From: [REDACTED]
To: [IPCN Enquiries Mailbox](#)
Cc: [Bradley James](#)
Subject: blue gum community School
Date: Thursday, 4 February 2021 10:51:58 AM
Attachments: [FW_da11192019_1_Rosemead Road Hornsby NSW 2077 Lot A DP327582.msg](#)

Proposed Community Preschool and Primary School - Noise Impact Assessment

1 Rosemead Road,
Hornsby,
NSW 2077.

PEER REVIEW

Figure 2:
Comparative
Barrier Acoustic
Performance for
1.8 metre Barriers
at 20 metres from
the Source to the
Barrier.

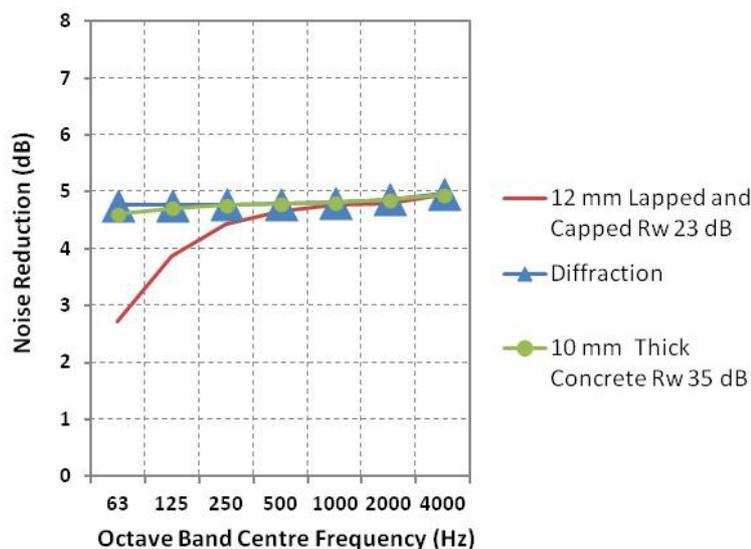
The sound attenuation of noise barriers, fences or screens can be calculated using the International Standard ISO 9613-2 (1996(E)) '*Acoustic – Attenuation of sound during propagation outdoors Part 2 General method of calculation*'. Factors required for the calculation are source to barrier distance, receiver to barrier distance, screen height, source height, receiver height and barrier width. For children in outdoor play areas the source to barrier distance is highly variable, however this is taken as a distance from the central play area to the residential boundary. In any case, this distance must be consistent with the geometric divergence used in Tables 1 and 2 above; hence 20 metres is used. The calculated results show that, for a 1.8 metre high barrier the acoustic noise reduction performance is not dependent upon the weighted sound reduction index (R_w) but on the diffraction (i.e. the sound level going over the barrier). Hence for a typical lapped and capped fence with an R_w of 23 dB (in the octave band centred on 1000 Hz - i.e. typical children sound frequency) the actual performance will be less than 5 dB. If the barrier was a 10 mm thick concrete wall with a weighted sound reduction index (R_w) of 37 dB (in the octave band centred on 1000 Hz) the actual performance will still be less than 5 dB. See Figure 2 below.

Figure 3: Comparative Barrier Acoustic Performance for 1.8 metre Barriers at 5 metres from the Source to the Barrier.

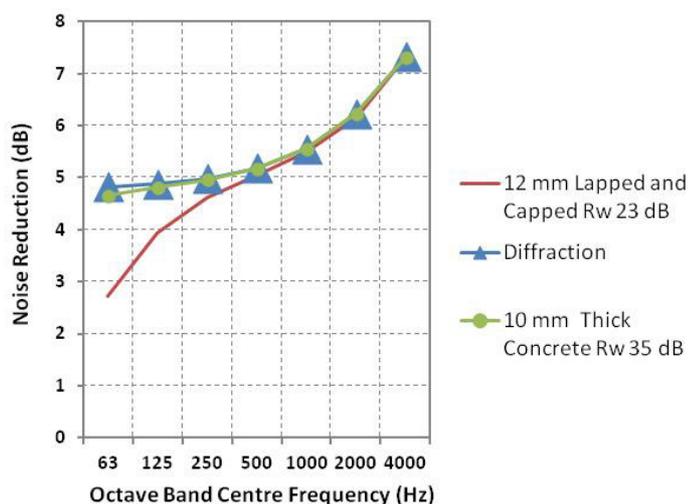
If it is assumed in the unlikely case that all of the children are only 5 metres from the barrier the actual performance will be less than 6 dB in the typical children sound frequency octave band centred on 1000 Hz as shown in Figure 3 below.

In addition, the effect of geometric divergence would reduce by 12 dB from 26 dB (i.e. $20 \log_{10} (20/1)$ dB) to 14 dB (i.e. $20 \log_{10} (5/1)$ dB).

Figure 4: Predicted Noise Levels for the Proposed Outdoor Play Area at two Neighbouring Premises with 1.8 metre Barriers, Compared to a Typical Background Noise Level.

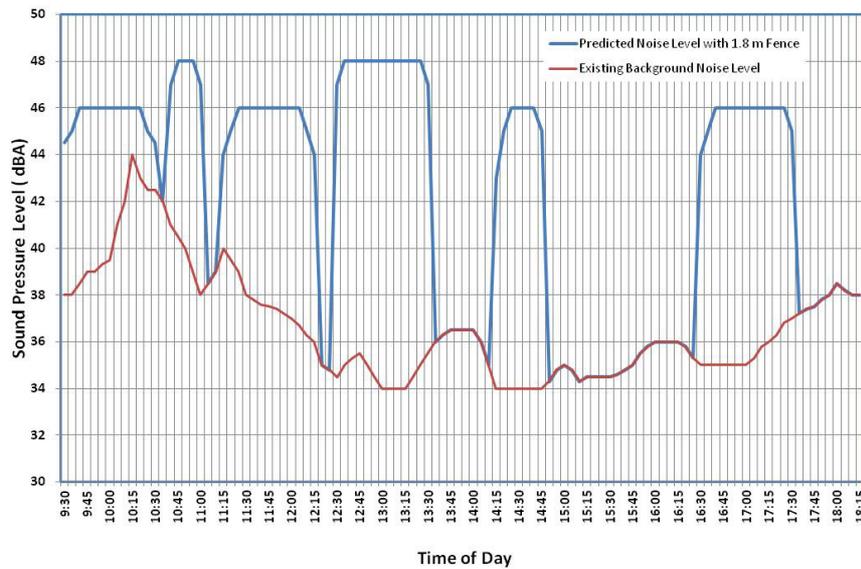
It is shown in Tables 1 and 2 above that the noise level ($L_{Aeq, 15 \text{ minutes}}$) at neighbouring premises are 51 dBA to 53 dBA without taking proposed acoustic fences into account. In section 6.2 it is shown that the proposed 1.8 metre high fence will provide just less than 6 dB overall noise reduction. This noise reduction is regardless of the weighted sound reduction index (R_w) and is due to limitations of diffraction. Therefore the actual noise level at neighbouring premises is 45 dBA to 47 dBA taking proposed acoustic fences into account. This noise level could occur for the proposed day time periods which are in excess of 4 hours as shown in Figure 4 below.

Hence the noise criteria to be applied in this case should be 5 dB and not 10 dB over the existing background noise level of **37 dBA** therefore **42 dBA**. The predicted 15 minute average noise from the outdoor play area without a noise barrier is **53 dBA** which exceeds the 42 dBA noise goal at the most affected residential properties (i.e. 1A Rosemead Road and 52 William Street) by **11 dBA** without a noise barrier. The highest predicted 15 minute average noise level ($L_{Aeq, 15 \text{ minute}}$) from the outdoor play area with the proposed 1.8 metre high fence is **48 dBA**, which exceeds the 42 dBA noise goal at the most affected residential properties by **6 dBA** with a noise barrier. When the existing background noise level is low, at say 1.00 pm, the predicted noise level from the outdoor play area will exceed the background noise level by 14 dB as shown in the Figure 4 below.
